CITY OF CUMBERLAND, MARYLAND  
CUMBERLAND WASTEWATER TREATMENT PLANT  
ENHANCED NUTRIENT REMOVAL (ENR) UPGRADE

CITY PROJECT NO. 15-03-WWTP

ADDENDUM NO. 2

December 29, 2008

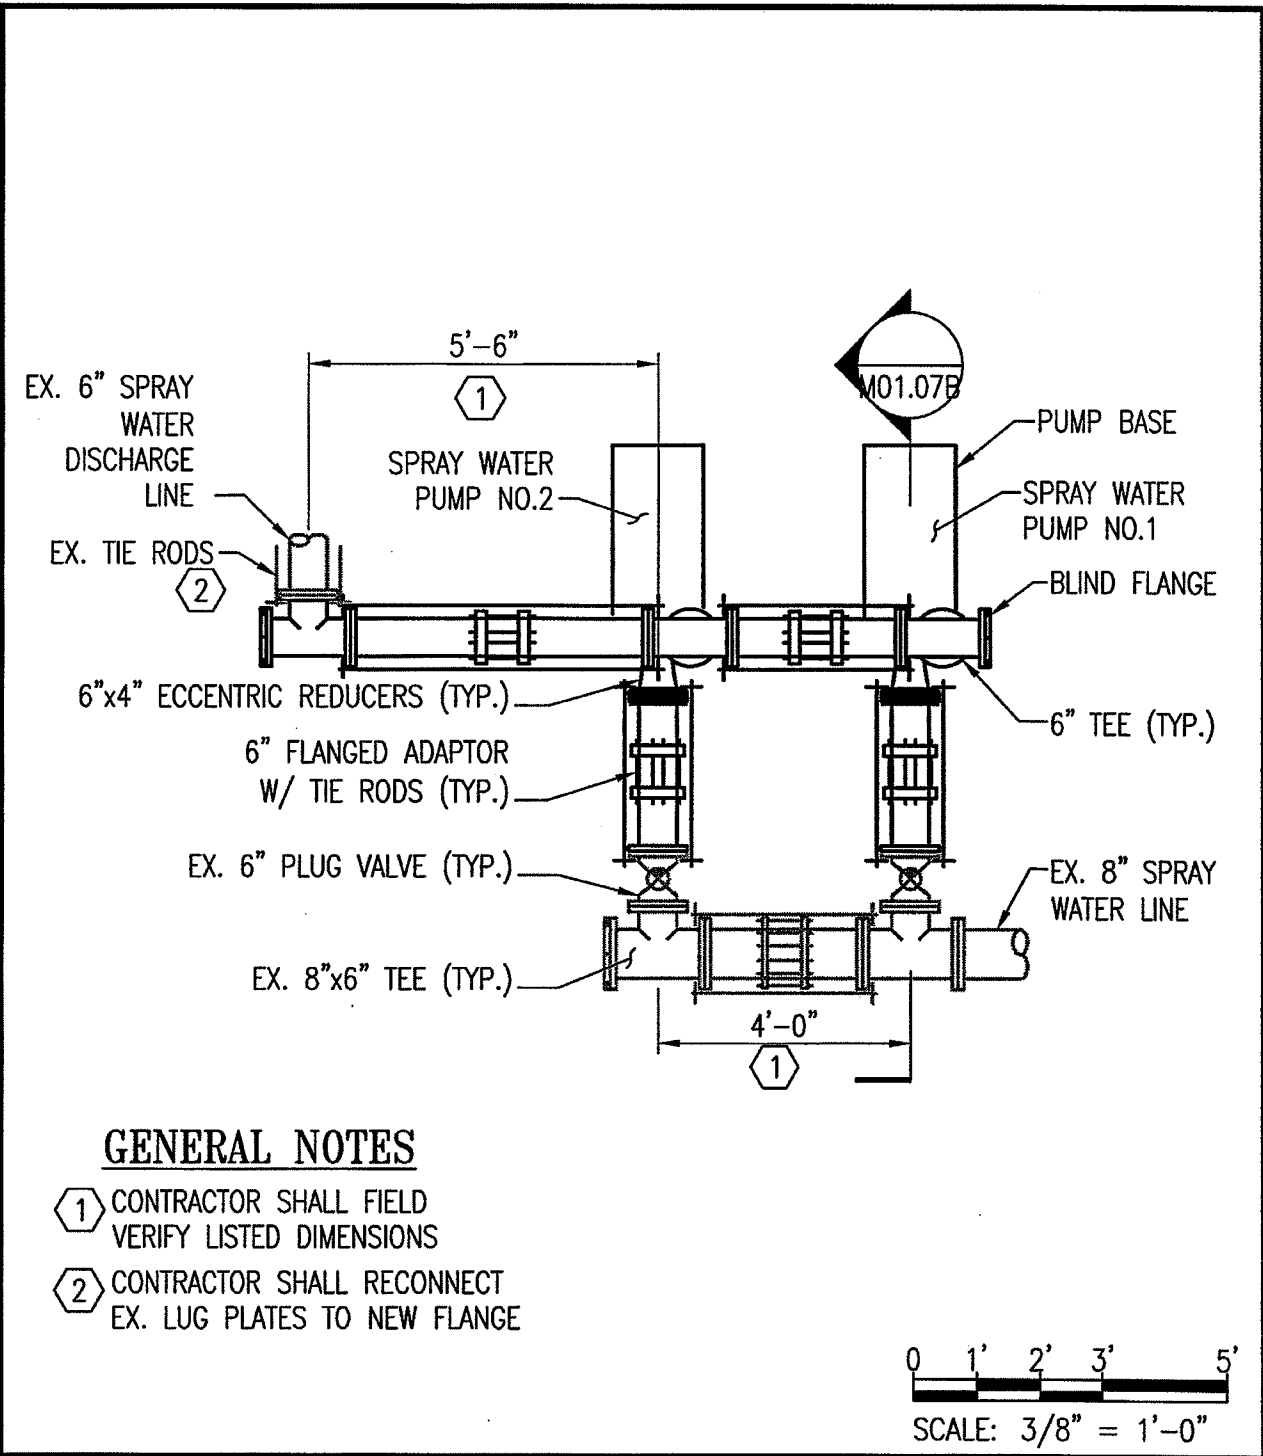
6. Drawing Sheet M01.07: ADD Spray Water Pump Detail / Plan View as shown on the attached sketch M01.07A.
7. Drawing Sheet M01.07: ADD Spray Water Pump Detail / Section as shown on the attached sketch M01.07B.
8. Drawing Sheet M01.07: ADD Spray Water Discharge Header Detail / Upper Level Plan as shown on the attached sketch M01.07C.
9. Drawing Sheet E03.09: ADD the following in the Drawing Notes:  
“Note 8: Mount Fixture 8’-0” AFF.  
Note 9: Mount Fixture 10’-0” AFF.”
10. Drawing Sheet I00.02: MODIFY drawing I00.02 to show AIT-324 going to AP2&ICP.
11. Drawing Sheet I00.03: MODIFY drawing I00.03 to show AIT-325 going to AP2&ICP
12. Drawing Sheet I00.04: MODIFY drawing I00.04 to show AIT-326 going to AP2&ICP

5. Refer to the spray water system that is identified in contract drawing M01.07. The discharge for this system is only shown in the schematic view and there doesn't appear to be a lower plan view that shows the actual routing of this line. Without this, it is impossible to assess the actual length of the line that has to be removed and re-installed.

16. Reference drawing sheet 75, 76, and 79 Reactor Spray Water Pump – On sheet 79, please furnish a full piping arrangement – plan and section/elevation for spray water pump suction and discharge tie-in to existing line.

*Answer: See sketches M01.07A and M01.07.B, added via Addendum No. 2 for detailed layout for the pumps and associated piping and valves.*

*Answer: See sketches M01.07A, M01.0.B and M01.07C, added via Addendum No. 2 for detailed layout for the pumps and associated piping and valves.*

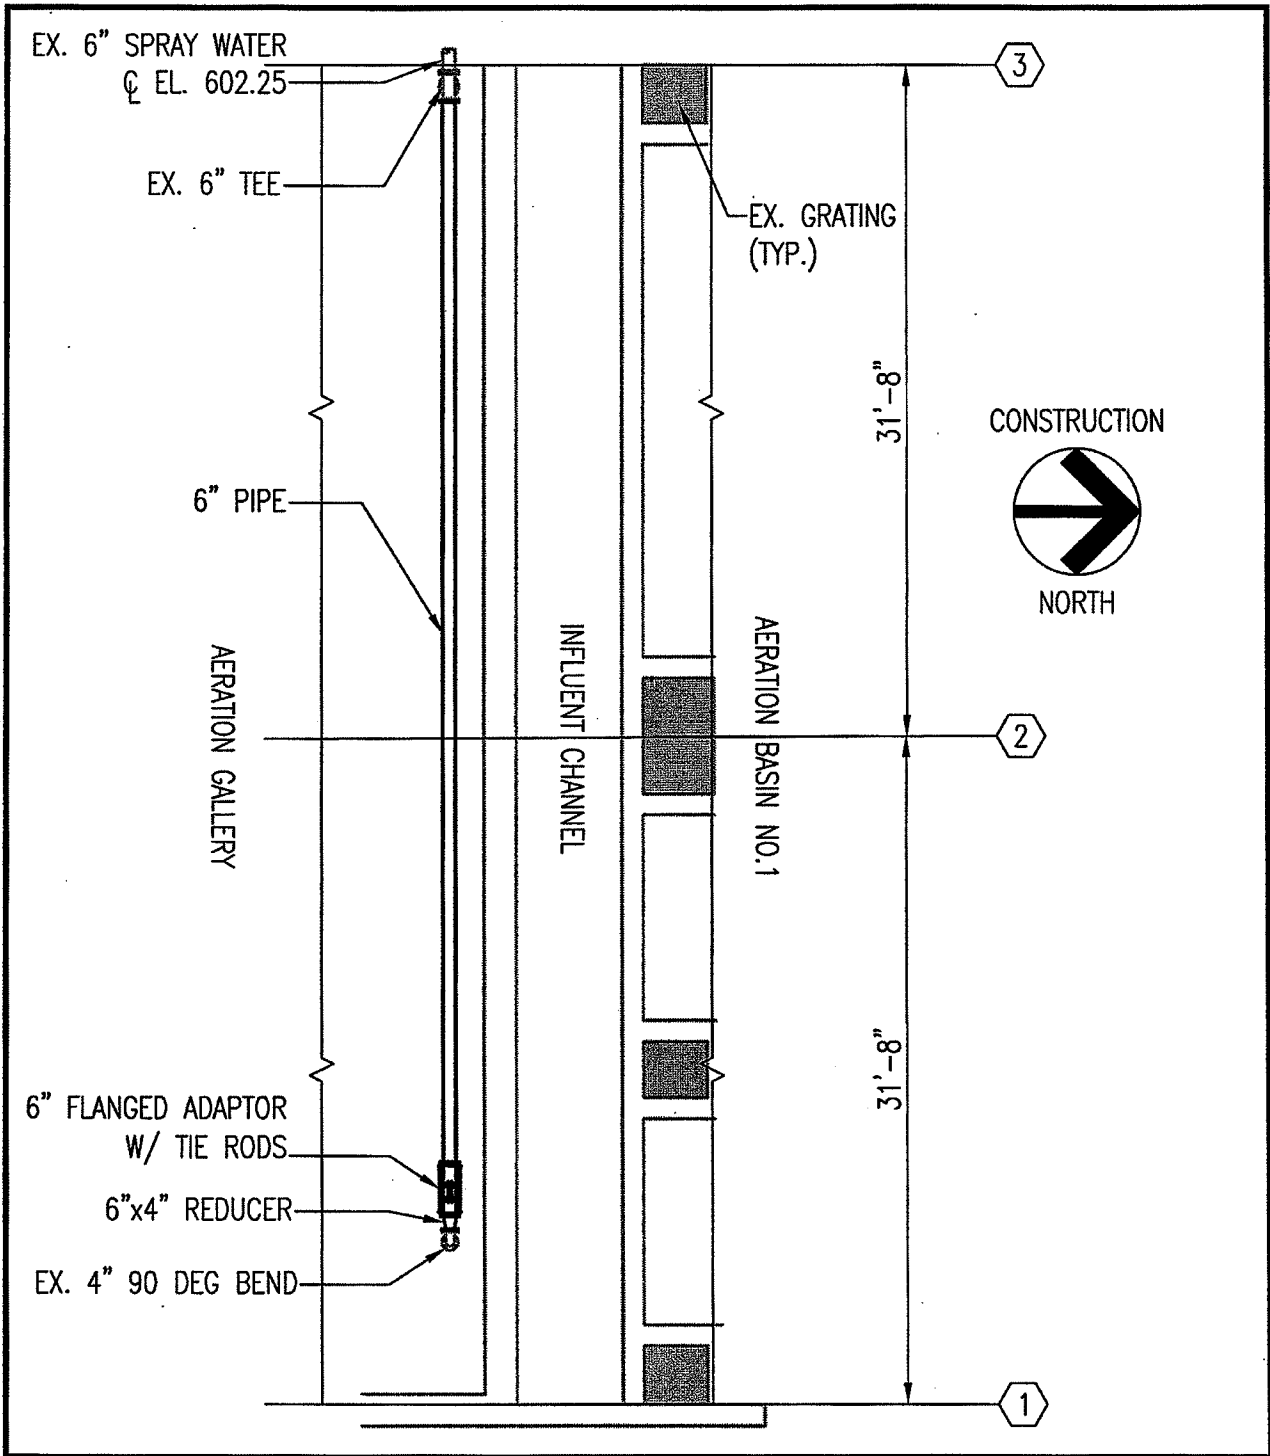
17. Reference drawing sheet 75 and 76 – Are 4” spray headers to be replaced and relocated as per notes on these drawings 75 and 76? Drawing 79 schematically shows them to be existing? If replacement is required, what is piping spec? Which is correct?

*Answer: Spray headers shall be replaced, not relocated. Refer to Section 15060, paragraph 2.01.A, second and ninth groups for specifications.*

*New spray water piping will include coverage for both sides of each pass of each reactor, the entire length of the reactor. Refer to the structural drawings for the length and width of the reactors. The transition shown on the schematic on M01.07 from 4" to 3" piping occurs approximately half way along the length of the reactors.*

*Refer to sketch M01.07C for the new 6" piping in the lower level of the operations building*
